Marrickville Metro Modification 11

Rearrangement of GFA, minor internal and external alterations, amendment to the timing of delivering the new roundabout at the intersection of Edinburgh Road and Sydney Steel Road and removal of one car parking space

Section 75W Modification Assessment (MP 0191 MOD11)

February 2021

Figure 6 | Proposed location for the car wash facility (grey) that will be subject to a separate DA on level 2 (Base source: Hames Sharley)

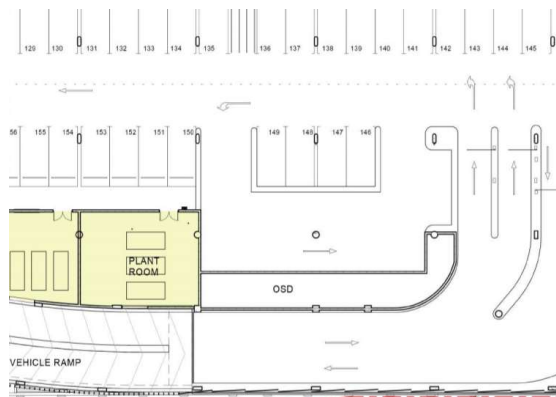
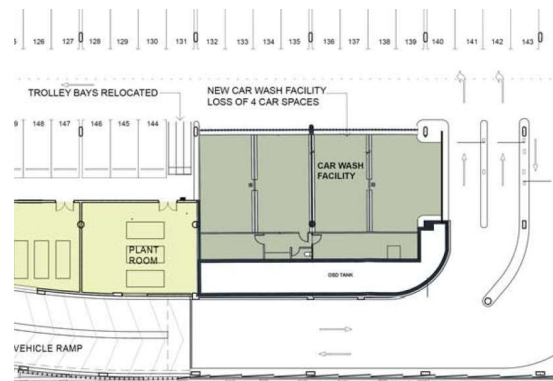
- provide an area of 269 m² on the level 2 car park within Stage 1B for the purposes of a future car wash (subject to a separate DA to Council).
- The Proponent notes the outer wall to the open air terrace will be less than 1.4 m in height, meaning that this area would not constitute GFA.

- the area of GFA within the level 2 car park is centrally located and setback at least 10 m from the boundaries. The appropriateness and impacts of any future car wash will be assessed in a future DA to Council

- there are no external changes to the building.
- The Department therefore recommends that condition A1 is amended to reflect the reduction of GFA to the discount department store and the plans in Condition A2 are amended accordingly. The Department also recommends that Condition A8 is amended to ensure that no approval is granted or implied for a future car wash.
